TRANSMITTAL OF SHOP DRAWINGS, EQUIPMENT DATA, MATERIAL SAMPLES, OR MANUFACTURER'S CERTIFICATES OF COMPLIANCE

DECISION RULES FOR EVALUATING INDIVIDUAL CONFIRMATORY SAMPLING RESULTS TO SUPPORT FIELD DECISIONS FOR SUPPLEMENTAL SEDIMENT REMOVAL PRIOR TO FORMAL COMPLIANCE DEMONSTRATION TESTING

NEW BEDFORD HARBOR SUPERFUND SITE
New Bedford, Massachusetts

Draft Tech Memo
Decision Rules For Evaluating.....

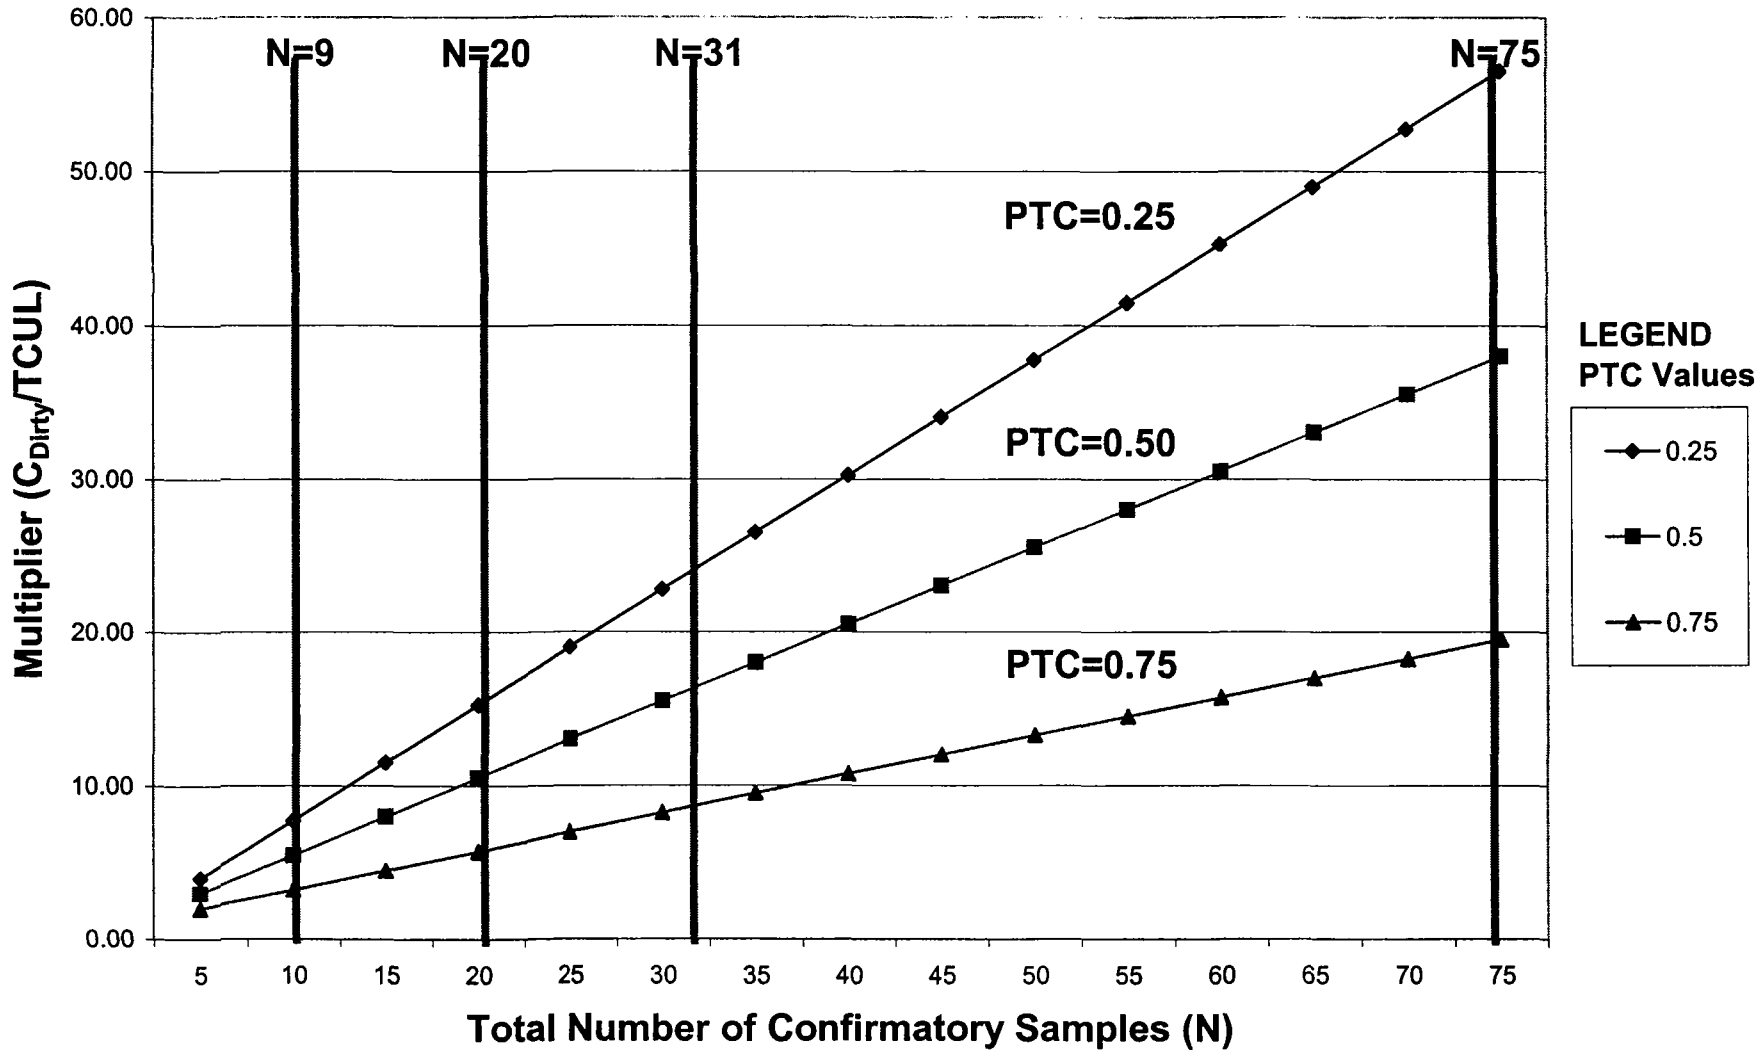
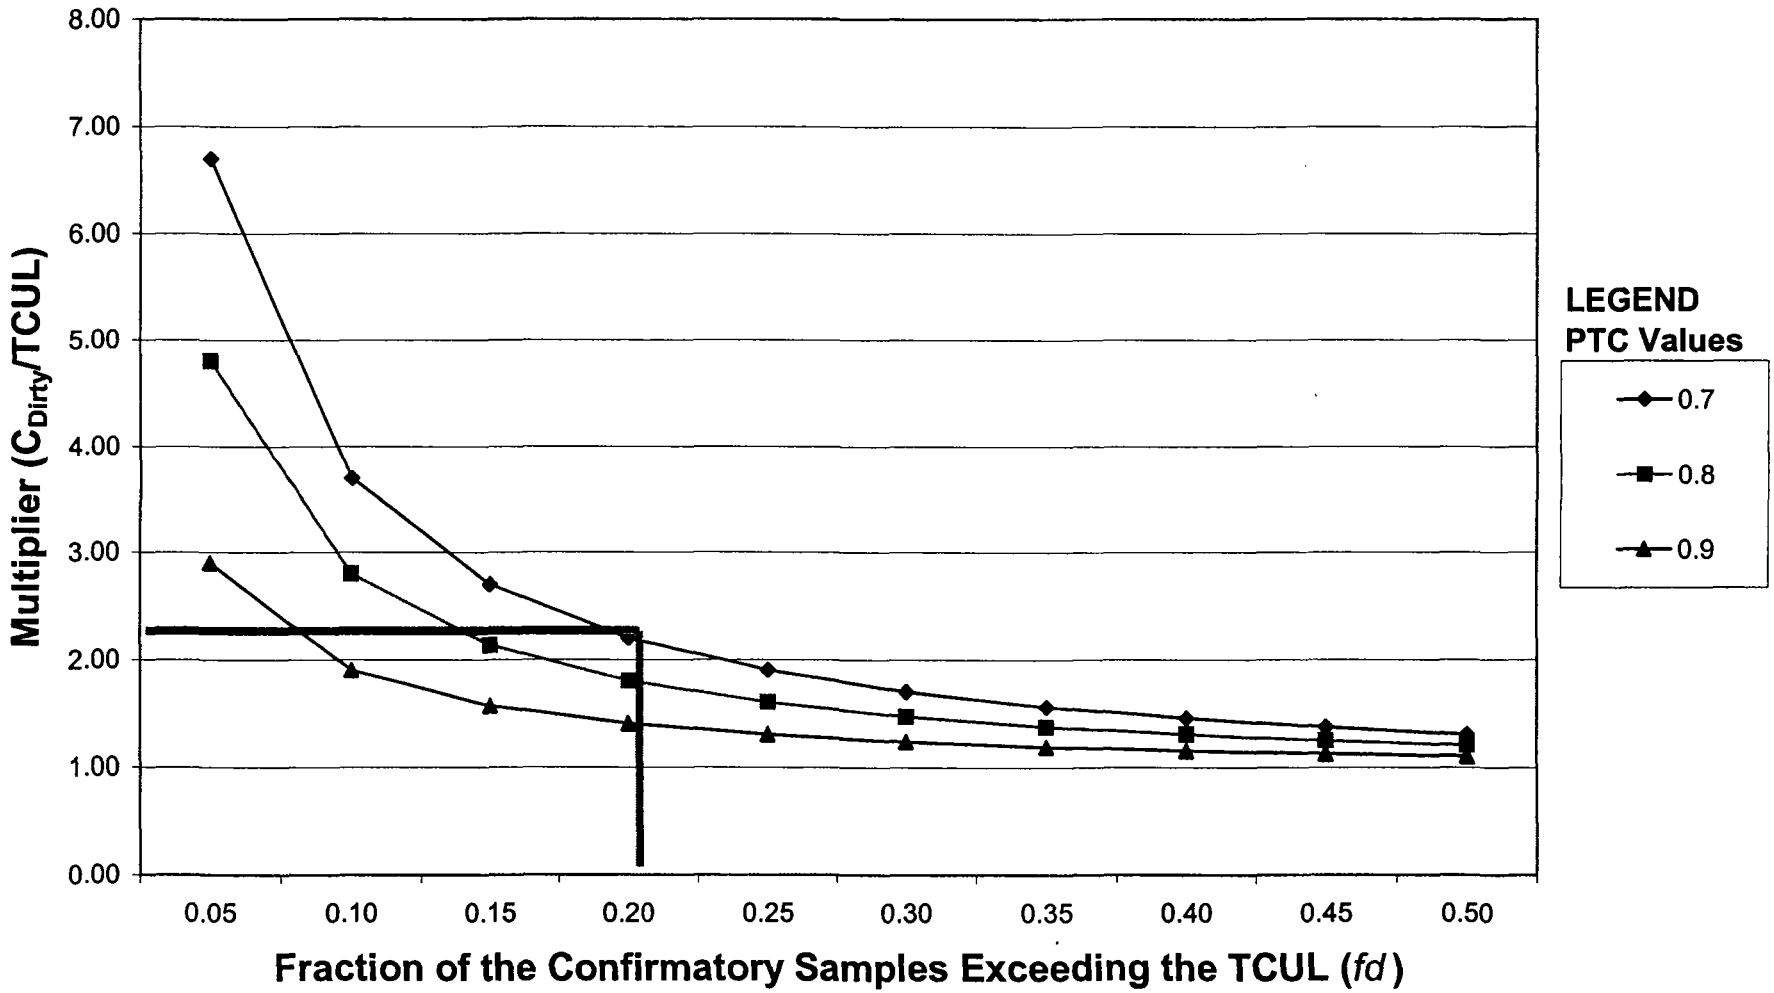
Not clear from Attachment A what the rationale was for selecting the multipliers of five and two.
